## APPENDIX A

#### Consent Order, *United States v. Lanier Pointe, LLC, et al.* (E.D.NC.)

**APPENDIX C**  
**RETROFIT PLAN FOR COTTAGES AT AZALEA APARTMENTS**

**APPENDIX D**  
**RETROFIT PLAN FOR AZALEA GARDENS APARTMENTS**

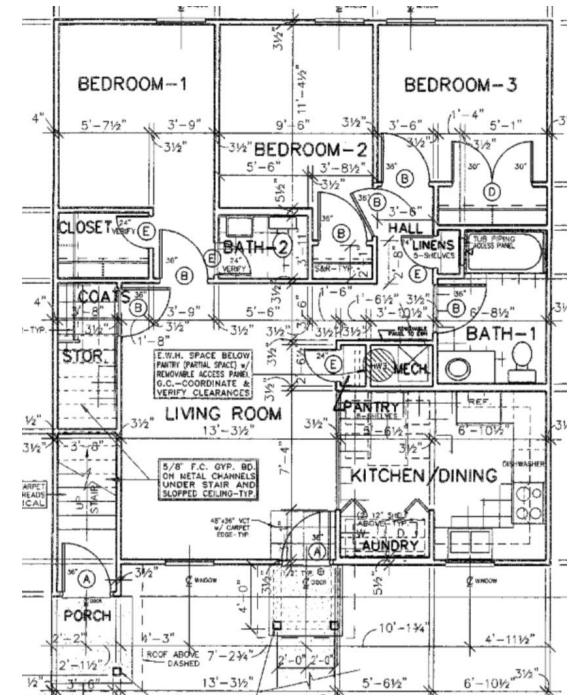
<u>Location</u>	<u>Height (inches)</u>	Unit 501 entrance	1-1/4	Unit 501 storage (storage closet is more than 24 inches deep)	1-1/4	<p>At unit entry doors: Provide beveled transition strips.</p> <p>At unit storage closet doors: Provide beveled transition strip or offer remediation upon request of tenants. If offered on tenant request, a durable-material placard, contrasting black text on white background, in minimum 14-point font, must be placed on the side of the patio door stating:</p>
<u>Location</u>	<u>Height (inches)</u>								
Unit 501 entrance	1-1/4								
Unit 501 storage (storage closet is more than 24 inches deep)	1-1/4

<p><i>Entrance door threshold interior side at Unit 501.</i></p>		<p>“A BEVEL TO ASSIST PERSONS WITH DISABILITIES FOR THIS THRESHOLD IS AVAILABLE UPON REQUEST. CONTACT MANAGEMENT.”</p>
<p>29</p>  <p><i>Linen storage in unit 501.</i></p>  <p><i>Measurement of clear opening.</i></p>	<p>The width of the clear opening at the linen closet doorway is 15-1/8 inches and the closet depth is 36 inches (minimum 31-5/8 inch clear opening width required).</p> <p>(Note: shelf is mounted on the long sidewall of the closet space.)</p>	<p>Widen door or install new back wall at closet such that closet depth is reduced to 24 inches.</p>

<p><i>Drinking fountain protruding depth.</i></p>								
7	 <p><i>Access aisle.</i></p>	<p>Leasing office designated accessible parking access aisle has running slopes greater than 2.0% (maximum 2% allowed).</p>

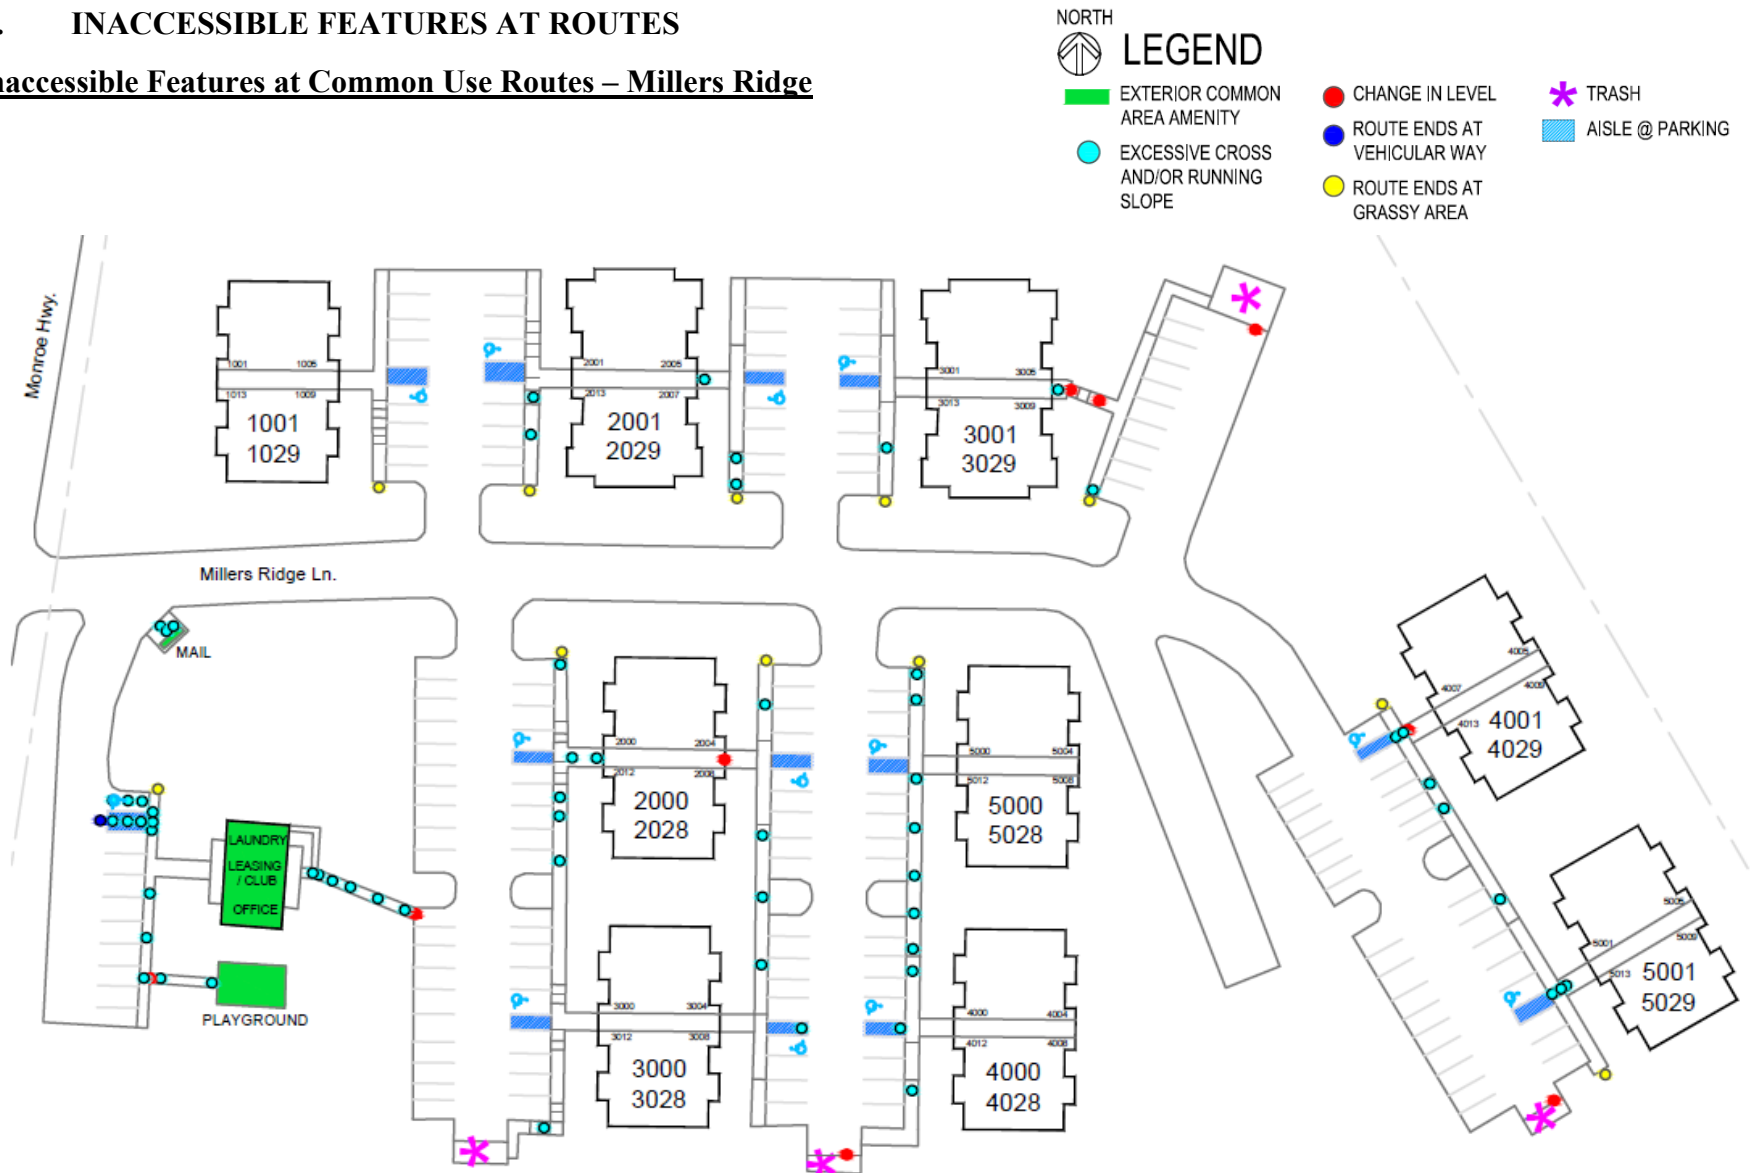
Protruding Objects		
6	 <p><i>Protruding objects in leasing office.</i></p>  <p><i>Drinking fountain protruding height.</i></p>	<p>Objects protrude more than 4 inches into the circulation path at heights greater than 27 inches and less than 80 inches (maximum 4 inch protruding objects allowed at heights greater than 27 inches and less than 80 inches).</p>	<p>Retrofit at fire extinguisher:</p> <ol style="list-style-type: none"> <li>1) Lower so that bottom of unit is less than 27 inches above the floor; or</li> <li>2) Install permanent cane detectable barrier under the fire extinguisher.</li> </ol> <p>Retrofit at drinking fountain:</p> <ol style="list-style-type: none"> <li>1) Lower so that bottom of unit is less than 27 inches above the floor; or</li> <li>2) Install permanent cane detectable barrier under edge of the drinking fountain such that the bottom is exactly 27 inches above the floor. Unit must be both cane detectable and have required clear knee space.</li> </ol>

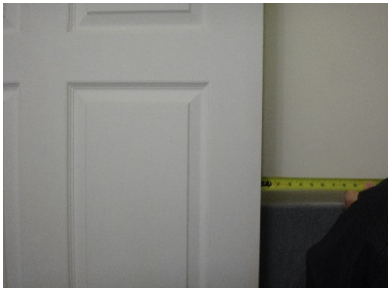
21	 <p><i>Patio door threshold at Unit 1005.</i></p>	<p>Door thresholds are more than 3/4 inches high and are not beveled (maximum 3/4 inch with bevel allowed).</p>

<u>Location</u>	<u>Height (inches)</u>	Unit 1005, patio	7/8	Unit 1005, storage	1-1/2	Unit 3004, patio	1	Unit 3004, storage	1-3/4	<p>Patio and storage closet doors:</p> <p>Provide beveled transition strip or offer remediation upon request of tenants. If offered on tenant request, a durable-material placard, contrasting black text on white background, in minimum 14-point font, must be placed on the side of the patio door stating: “A BEVEL TO ASSIST PERSONS WITH DISABILITIES FOR THIS THRESHOLD IS AVAILABLE UPON REQUEST. CONTACT MANAGEMENT.”</p>
<u>Location</u>	<u>Height (inches)</u>												
Unit 1005, patio	7/8												
Unit 1005, storage	1-1/2												
Unit 3004, patio	1												
Unit 3004, storage	1-3/4

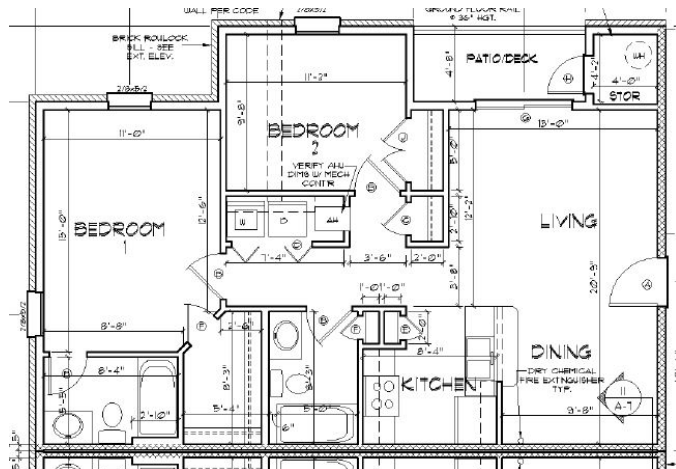
26	 <p><i>Entry door threshold interior side at Unit 1009.</i></p>	<p>Door thresholds are more than 3/4 inches high at the interior face and are not beveled (maximum 3/4 inch with bevel allowed).</p>

*Storage room door threshold at Unit 2005.*

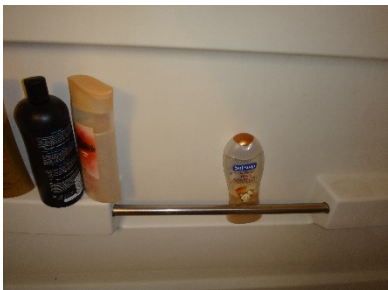
32
